Subject: RESPONSE TO NRC REQUEST FOR ADDITIONAL INFORMATION ON  
ARROW-PAK EXEMPTION REQUEST  
(Docket No. 71-9218, TAC No. L23811)

### RAI Responses and Summary of Changes to Revision 0 of the TRUPACT-II Safety Analysis Report (SAR) Addendum for ARROW-PAK

**Figure 2 – Tensile Stress vs. Strain at 1 in/s**

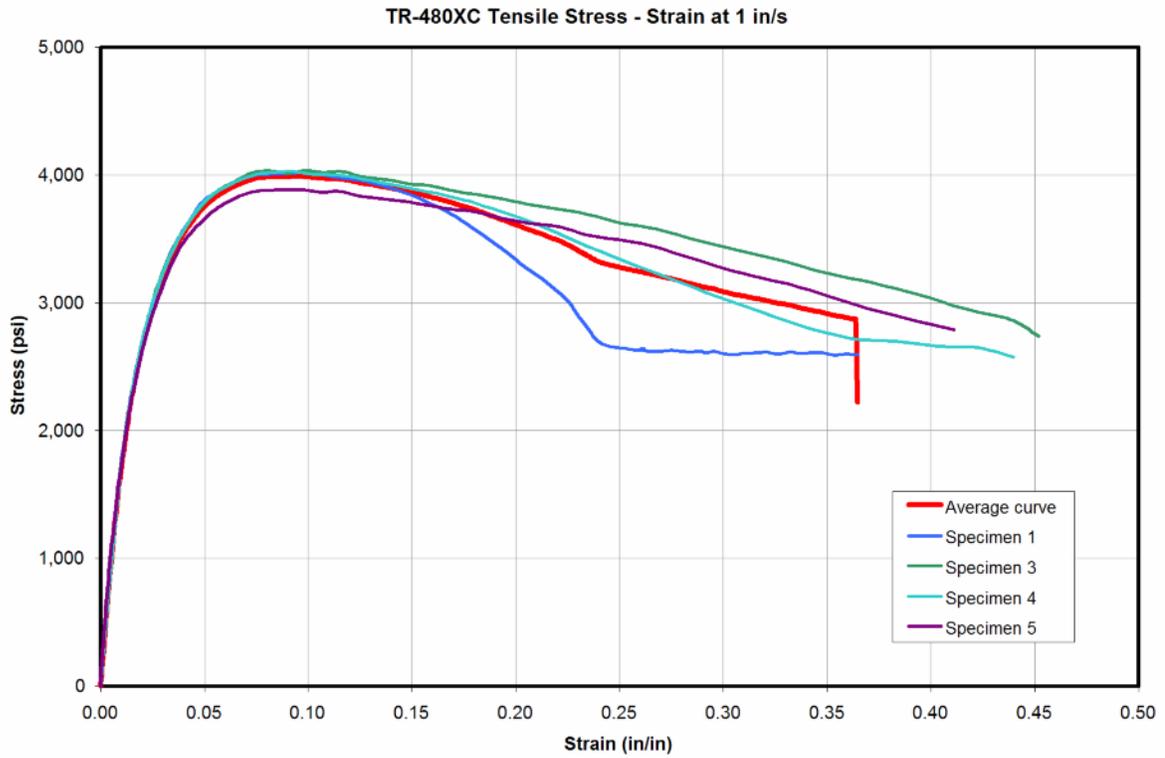
- 2-9 Provide stress-strain curves (engineering and true) for the EHMW-HDPE material in tension and compression at various temperatures (70°F to 200°F), various strain rates, and subjected to stresses for short (<10 hours) to long durations (10,000 hours). Include data that covers all strain rates that may occur in all service in which the ARROW-PAK may be used.**

Figure 2 presents the chart and hard-data of multiple tensile-tests at “high-speed”. The standard ASTM D638 tensile test is 2 inches per minute (0.0333 inches per second). The Figure 2 data, at 1 inch per second, is 30 times faster than the standard test velocity. The tensile yield stress at 1 inch per second is approximately 30% higher than at 0.0333 inches per second (see subsequent Figure 7). The hydrogen deflagration velocity is approximately 279 feet per second (3,350 inches per second) within an ARROW-PAK container, which is over 3,000 times faster still.

Even at this very high deflagration velocity, the HDPE material remains ductile, and exhibits strain-rate hardening such that the HDPE yield stress is over 5 times the ASTM D638 tensile yield-stress test value at 0.0333 inches per second (see Figure 7). There is no standardized test for “ultra-high” velocity tensile-testing of polymers. (Compare the above strain velocities to a “high-explosive” minimum detonation velocity, which is known to be above 26,000 inches per second.)

**Figure 13** – ARROW-PAK/ICV Sensitivity Model Using Solid Elements for Void Spaces

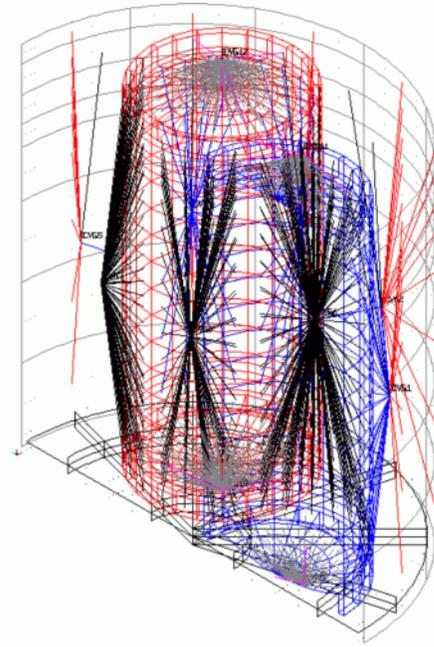
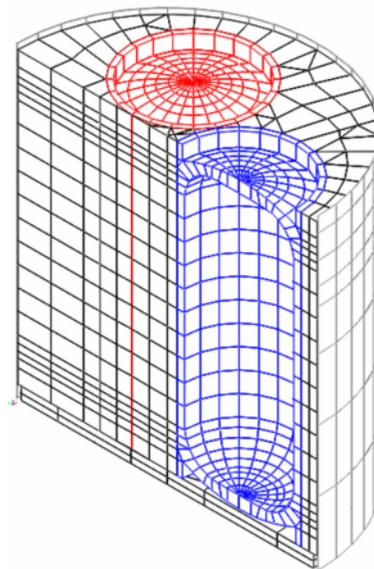
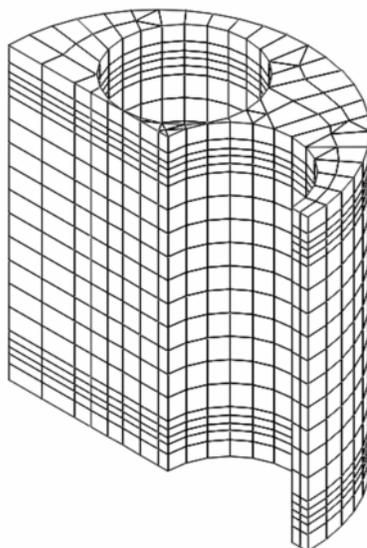
- 3-4 Justify the inclusion of convection, besides conduction and radiation, when modeling the heat transfer between the ARROW-PAKs and the inner surfaces of the TRUPACT II package, as suggested in Section 3.4.1.2 of the application. Provide all the details about modeling convection with SINDA/FLUINT, including any correlation and assumption that may have been used. Describe the flow pattern that may be developed in the inner space between ARROW-PAKs and TRUPACT-II, and how buoyancy will help move heat from the hot to the cold bodies. Discuss validation/benchmarking efforts that support the use of the SINDA/FLUINT convection option for such unusually shaped inner space. Indicate the percentage of the total heat the SINDA/FLUINT predicts to be attributed to convection, conduction and radiation. Indicate what the ARROW-PAK sidewall temperature would be if convection were not taken into consideration.**

To validate that the SAR model was conservatively computing the thermal linkage between the ARROW-PAKs and the ICV, the SAR thermal modeling was modified to remove the convection/conduction based links and to substitute solid elements instead to represent the void air spaces. Figure 11 presents the modeling of the ARROW-PAKs and a portion of the ICV sidewall as used in the SAR modeling, while Figure 12 provides a graphic representation of some of the convection/conduction based links between the ARROW-PAKs and the ICV. Figure 13 presents the combined solids representation of the ARROW-PAKs, the ICV sidewall, and the void air spaces used for the sensitivity modeling. Figure 14 illustrates the solids modeling for the void air spaces which replace the convection/conduction based links illustrated in Figure 12. Under the solids modeling approach, the void air spaces assume homogenous conduction in all directions based on the thermal conductivity of air as a

function of temperature. Heat transfer via radiation was computed in the same manner as with the SAR analysis.

The sensitivity model was exercised for NCT hot condition at the SAR identified limiting decay heat loadings of 25.2 watts for evenly distributed loading and 22.7 watts for unevenly distributed loading. Table 1 presents a comparison of the predicted temperatures using the SAR thermal model and the results from the sensitivity model. The SAR results are taken from Table 3-3 of the SAR. As can be seen from Table 1, the results from the SAR model equal or bound those obtained from the sensitivity thermal model for the evaluated cases for all but one temperature point (i.e., the centerline of the 55-gallon drum in ARROW-PAK No. 1) and in that case, the difference is only a few tenths of a degree – sufficient enough to round the temperature up instead of down. The biggest difference between the analysis methodologies occurs in the computed bulk average air temperature within the ICV cavity where the SAR model methodology uses a higher temperature resulting from arithmetic averaging, while the sensitivity model uses a volumetric averaging approach to estimate the bulk average air temperature. The higher bulk air temperatures are conservative for the purposes of computing the operating pressure within the ICV.

These results confirm that the results presented in the SAR are conservatively estimated based on the use of conduction only type of linkages between the ARROW-PAKs and the ICV surfaces. SAR Section 3.4.1.2 has been modified to state this point and to clarify that the convection/conduction links used in the SAR model effectively degrade to conduction only for the temperature differences and geometries involved.
